CONTRACT PACKAGE C-6: REPLIES TO PRE-TENDER QUERIES (Set 1)_24.04.2024

Contract Package C-6 : Design and Construction of Civil Works (Earthwork, Bridges, Station Buildings, Retaining Walls & other miscellaneous Works) and General Electrical Services works from km 61.50 to km 126.03 between HORC station New Patli and IR station Harsana Kalan and connectivities from Badsa Station of HORC to existing IR Sultanpur station and Mandothi station of HORC to existing IR Asaudah Station in connection with laying of New BG Double Railway line of HORC Project.

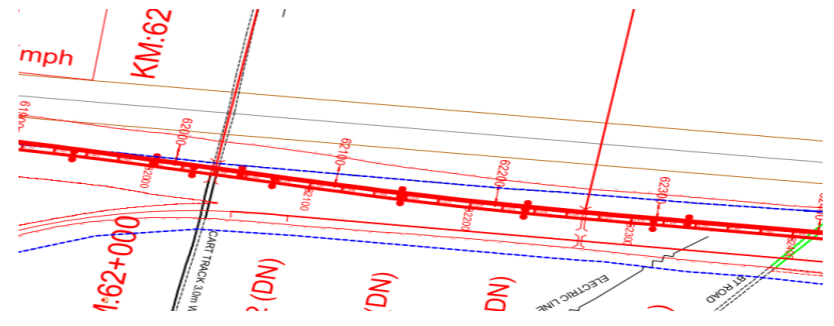
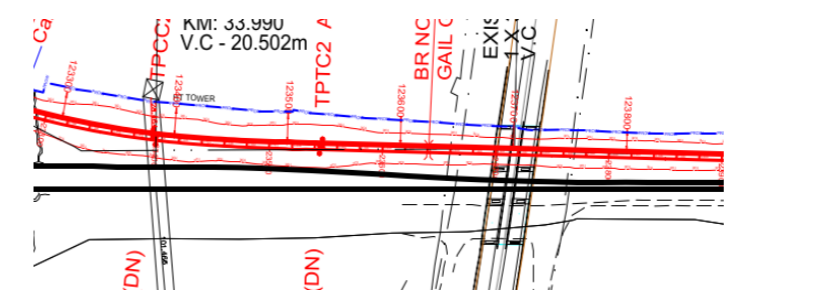
104	PCC, Part A, 14.2, Page No-9	Total Advance Payment- 05% of the Accepted Contract Amount less Provisional Sum payable in the currencies and proportions in which the Accepted Contract Amount is payable.	We request you to provide 10% interest free mobilization advance against Bank guarantee of equal amount. This will help us in maintaining the cash flow	Tender conditions remain unchanged.

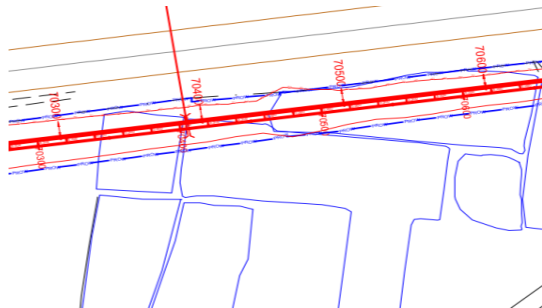
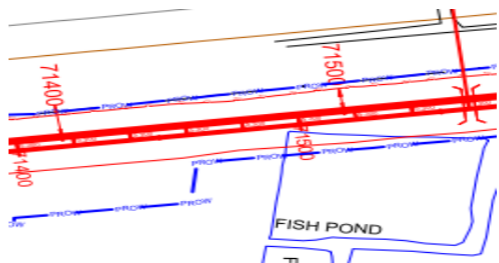
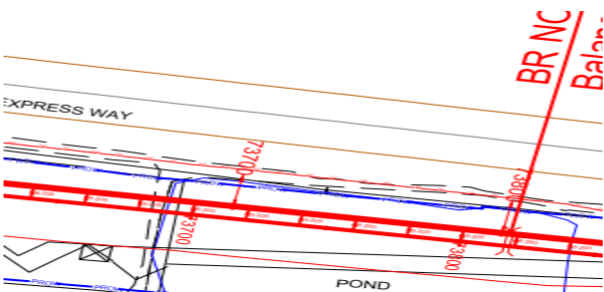
115	General	RUB	The Bidder understands that any additional land or costs related to diversions, construction, or obtaining permission from relevant authorities in the case that RUB approaches exceed beyond the ROW shall come under the employer's scope.	Refer Sub-Clause 1.4 and Annexure F-7 of Section VII-2: Employer's Requirements-Functional , Clause 2 of Section VII-5: Employer's Requirements-Outline Design Specifications (ODS)-Civil & BLT, Sub-Clause 5.8.5 b) 1 of Appendix 5 and Sub-Clause 10.3.2 of Appendix 10 of Section VII-9: Employer's Requirements-Appendices, Part 2 of Tender Document.
116	Bid Submission Date		Kindly extend the date of bid submission by one month, i.e., 22-06-2024.	Tender Conditions remain unchanged.

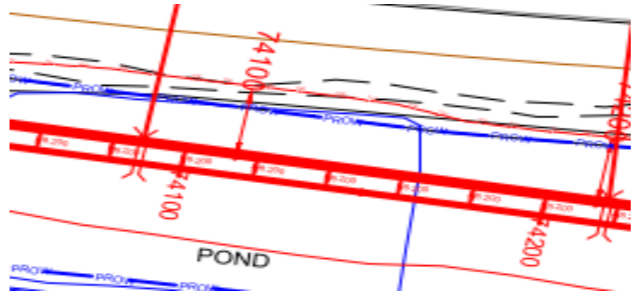
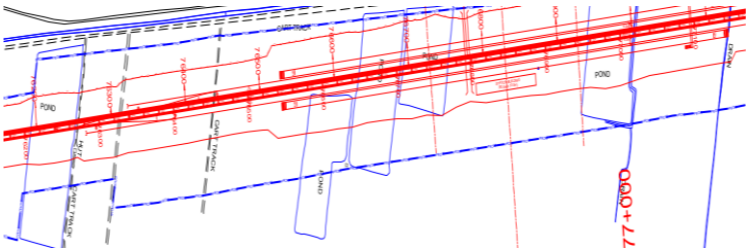
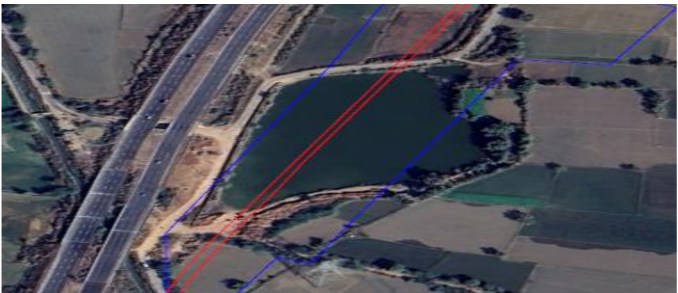
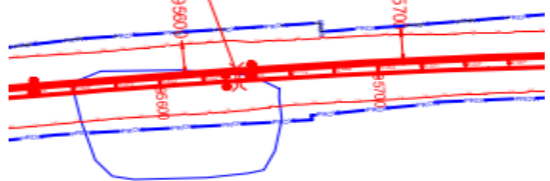
123	General	Track distance	Kindly provide the track distance between Down line and parellel track running from CH:123+300 to 125820. 	Refer ESP of New Harsana Kalan given in Attachment 1 of Corrigendum No. 1
